**TOWN OF BAY HARBOR ISLANDS
MORRIS N. BROAD COMMUNITY CENTER
1175 95TH STREET
BAY HARBOR ISLANDS, FL 33154**

DESIGN REVIEW BOARD

**February 13, 2024
7:00 PM**

Subject: Site Development Plan Application – Exterior Renovations
Existing Multi-Family Residential Complex (9 DU)
1060 95th Street
Bay Harbor Islands Acct. No. SPR23-000027
MMPA Acct. No. 01-0702- 1171

1 TYP. A/C SCREENING PLAN CALLOUT -DRB Copy 1
DRB.10 Scale: 1/4" = 1'-0"

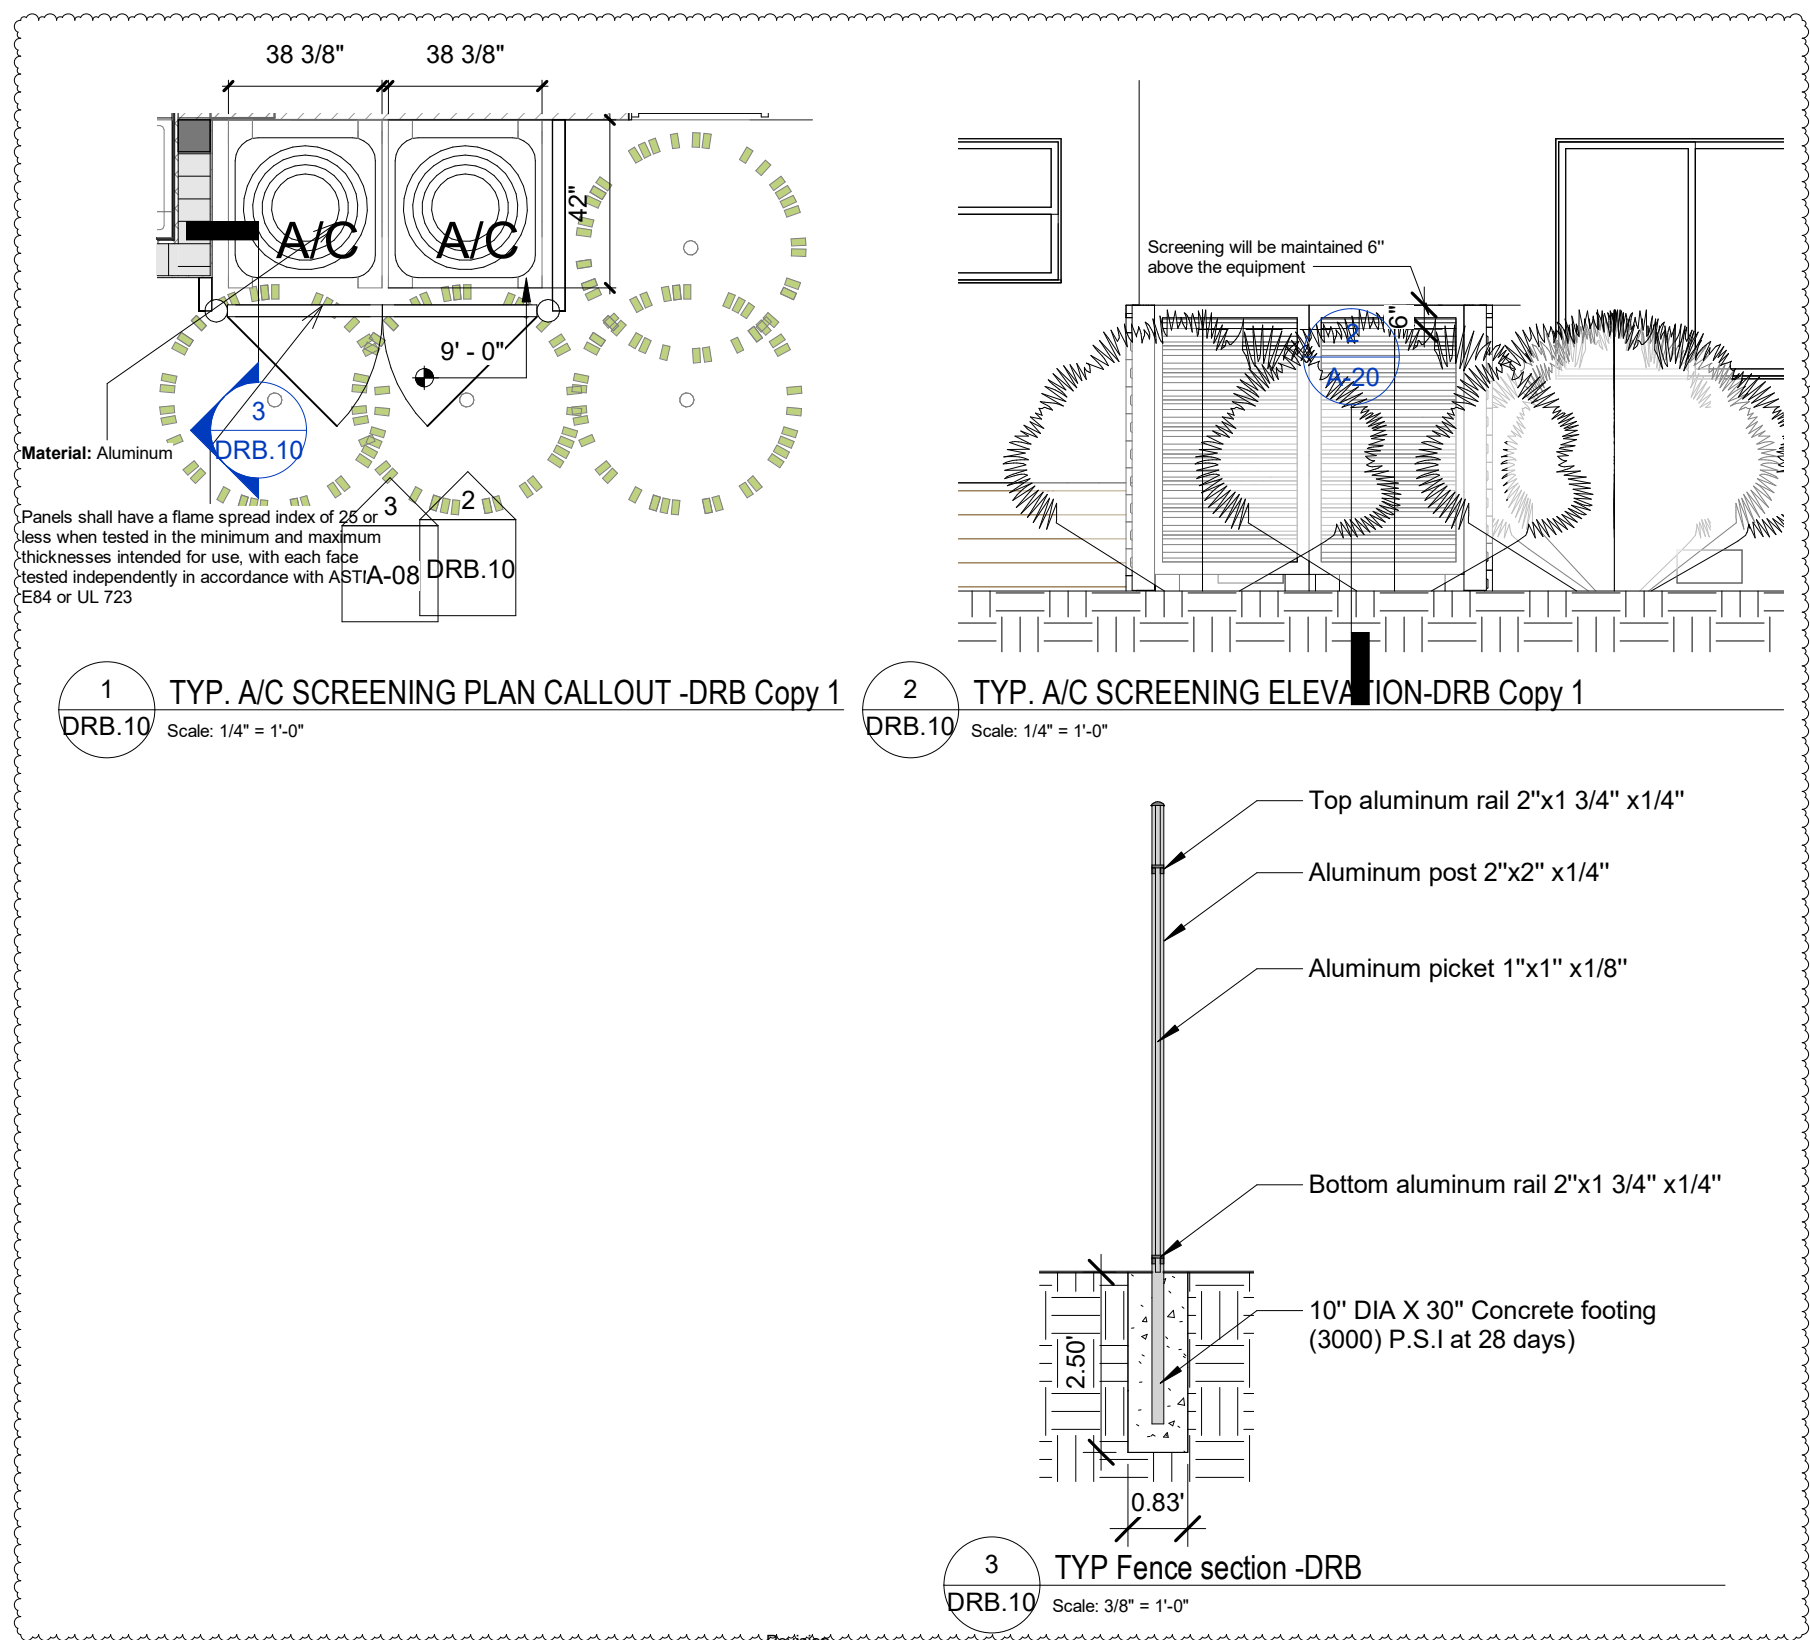
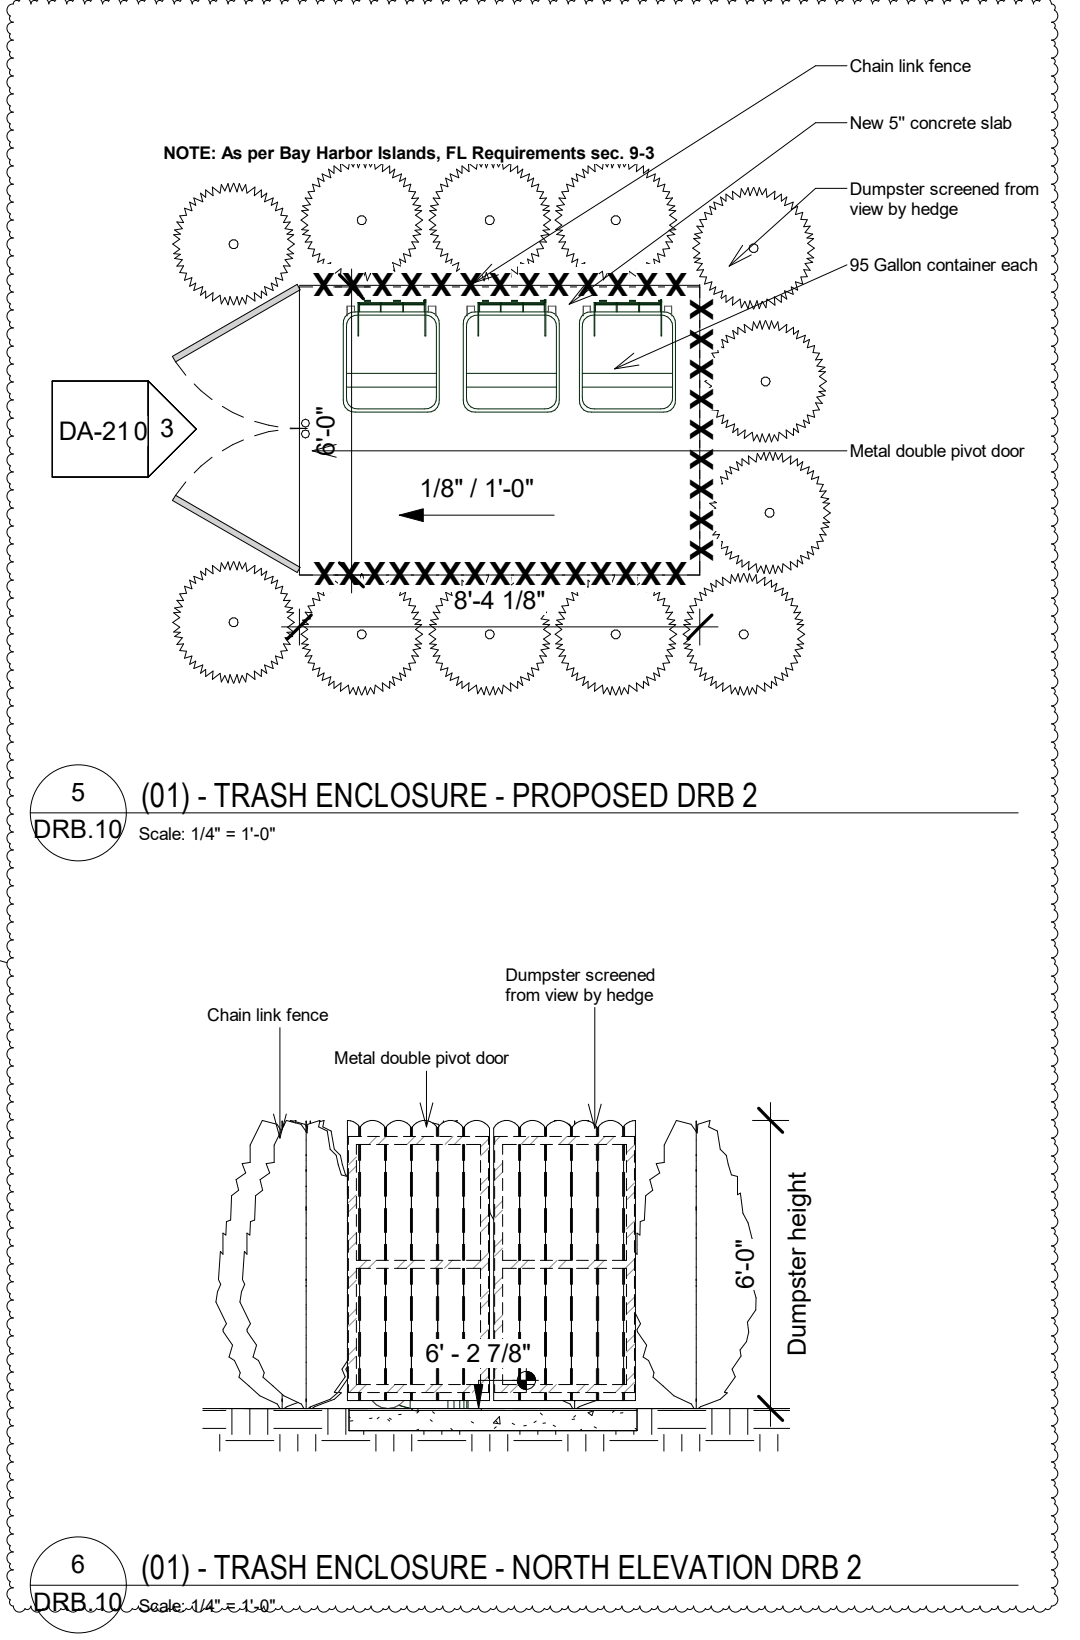
Revision Number	Revision	Date
49	3.The new A/C units appear to be elevated to meet FEMA / FBC requirements, however, they need to be screed. The code requires a physical barrier (Fence/wall) with supplemental landscaping. (Landscaping alone is not sufficient). Call out type of proposed screening including material, color and height.	09-14-2023
62	12.Provide information on existing/proposed trash and garage disposal storage system including the proposed required screening.	09-14-2023

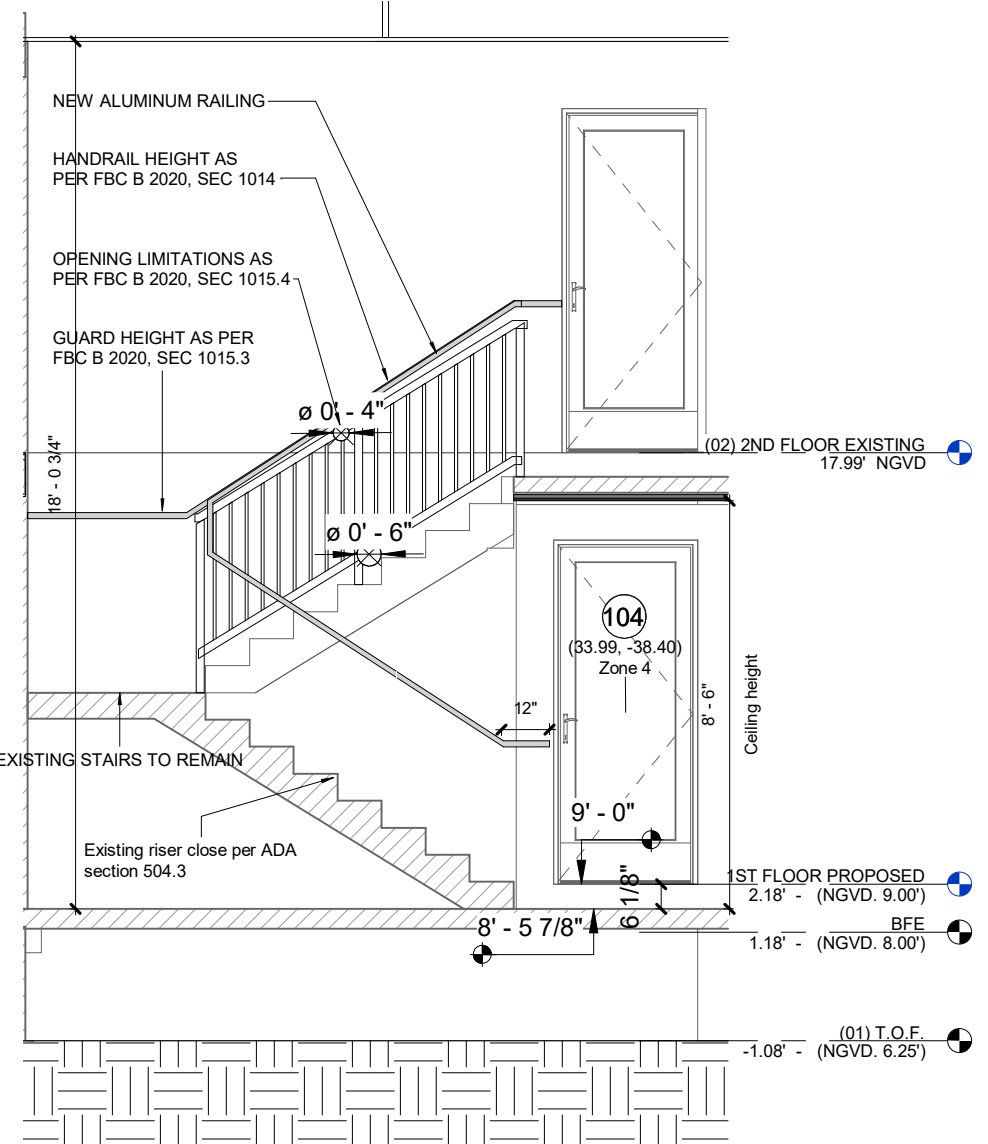
2. Provide height of the proposed railings and color and materials.
